STATE OF FLORIDA  
DEPARTMENT OF ENVIRONMENTAL PROTECTION  
**NOTICE OF PERMIT**

DEP File No. 0990646-001-AC  
Permit No. PSD-FL-354  
FPL West County Energy Center  
Two 1,250 MW Combined Cycle Units  
Palm Beach County

**TECHNICAL EVALUATION  
AND  
PRELIMINARY DETERMINATION**

Florida Power and Light Company  
West County Energy Center

Figure 1. Proposed Location FPL WCEC Figure 2. Aerial View, Rendition from Northeast

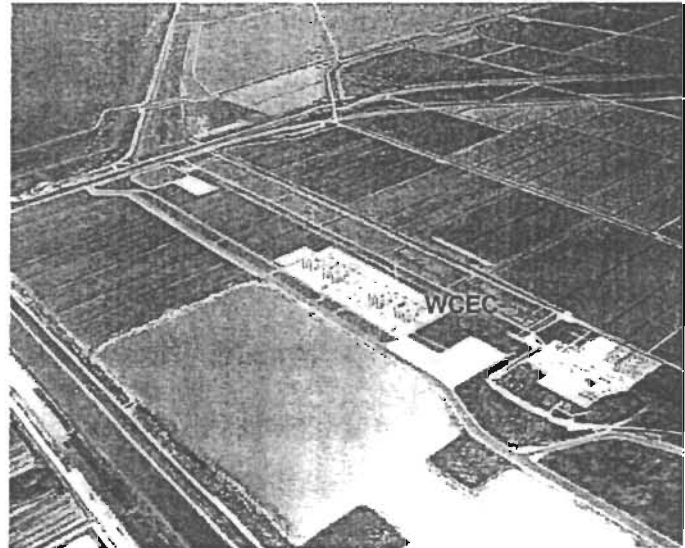
1. **Page 2, Figure 1:** SW St. Lucie should be removed from this Figure, as it is no longer a proposed FPL project.
2. **Page 3, Project Description, first paragraph:** For accuracy and consistency with the Draft PSD permit, please make the corrections indicated below:
